Project Name: **Westerlea View Lofts: 54 unit residential development plus 1 commercial space**  
Project ID: #2016-184 (Subdivision & Site Plan) and  
#2016-185 (Conditional Use Inclusionary Zoning)  
Address: 75 Chestnut Street CBL: 26/E/10  
Applicant: A&M Partners Inc  
Planner: Jean Fraser

**Subject:** B7 Design Review – 75 Chestnut Street

**Subject:** B7 Design Review Site Plan Amendment – 75 Chestnut Street

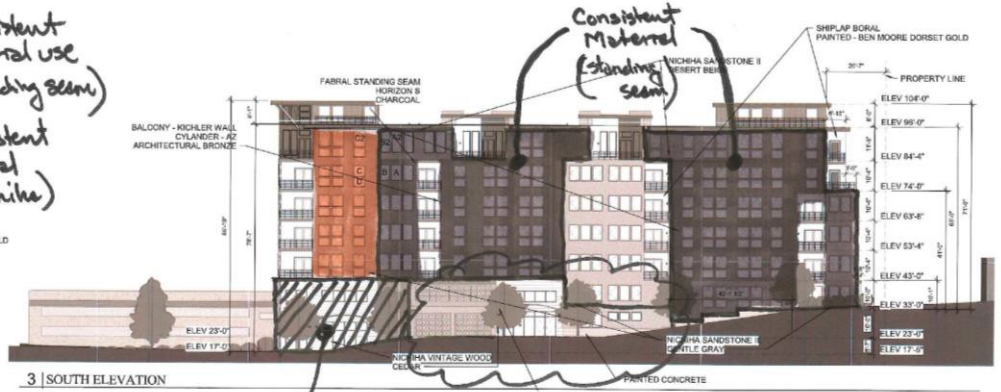
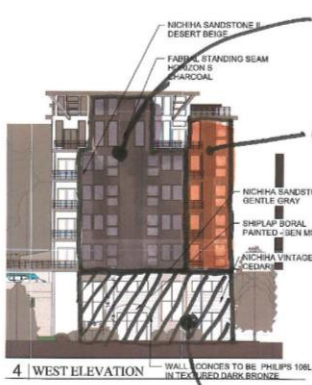
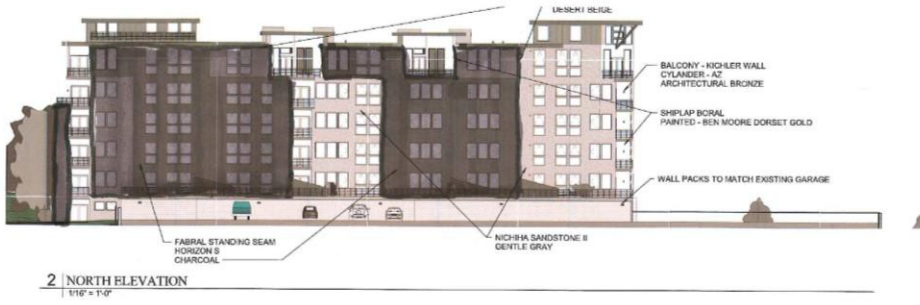
- The base of the building should be more consistently defined, especially on the Chestnut Street side. At this point, that can best be achieved through articulation, material placement and detailing. The corner, double-height live-work unit could also be more substantially differentiated from the other masses of the building.

- The level of detail and articulation on the Chestnut Street elevation is not sufficient, especially at the street level. Material changes are mostly arbitrary and other than at the entrance, do not correspond to uses or plane changes. Revisions to meet this standard could come in form of enclosure; articulation and detail (reveals, dimensional trim, material transitions, detail); placement of material that corresponds with uses

Consistent material use (standing seam)  
Consistent material (Nichha)

Consistent Material (standing seam)

Consistent material use differentiating this corner unit

Ped level articulation + match floor plans

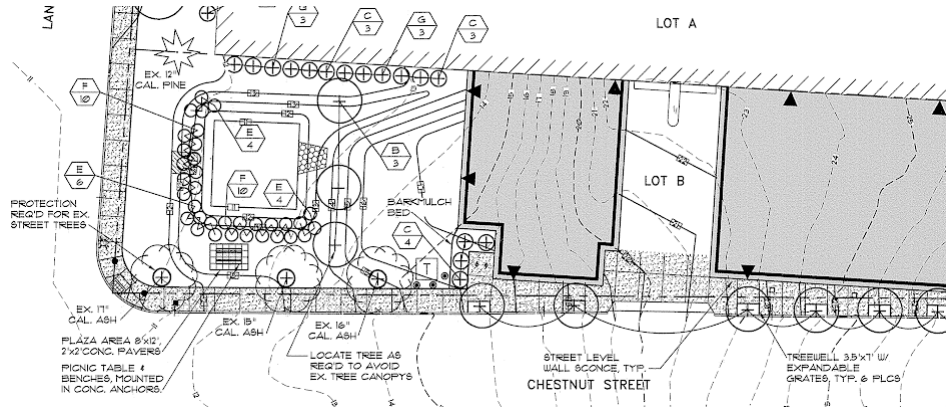
The proposed building angle with columns appears that it could be challenging for snow clearing and pedestrian travel. We note in the downtown that while tree grates are accessible ped traffic seems to avoid walking on them. Truly - the columns appear to pose the biggest challenge to an open, navigable with the closeness of the street trees.

- a) Adjust the spacing of the trees on the uphill side of Chestnut. Shown as H 6, by moving the second tree down from Oxford Street slightly uphill away from the nearby column. The concrete scoring joint marks could be adjusted to fit the new alignment.
- b) Remove (1) tree closest to the column and replant a new tree near the corner of Lancaster Street below the stormwater feature, on the lawn area. This would be between the F-10 & E-6 plant tags on the landscape plan, see below.

My preference would be the later as that space would provide a larger root zone to help the tree establish. From experience the street trees in the sidewalk cutouts have limitations due to lack for root space, (I am thinking the long term view from the tree perspective)
